Product Change Notice

PCN 001

NetBurner Part Numbers: MOD5441X-100IR, MOD5441X-200IR

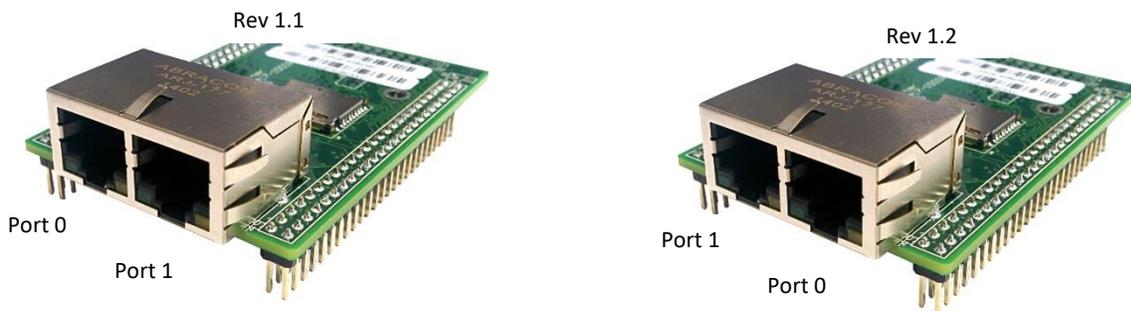
Ethernet interface independent mode port number change

Note: above images show the -100 version with the Ethernet jacks installed. This change effects the -200 version in the same manor.

Reason for modification: Ethernet port number compatibility between Mod54415 and Mod54417 to enable them to be physically interchangeable in Customer product designs intended to support both single and dual Ethernet options.

- No effect when ports are operated in network switch mode.
- No effect when ports use IP routing to determine which port to use (independent mode)
- We expect nearly all applications to fall under the above “no effect” categories. However, it will effect applications that care which physical port location is connected to a specific network and use function calls such as ConnectVia() that require a specific logical port number parameter. Also effects applications that use the interface number option for the web server interface. The application source code would need to be changed to specify the modified port numbers in revision 1.2: change port 0 to port 1 and port 1 to port 0.
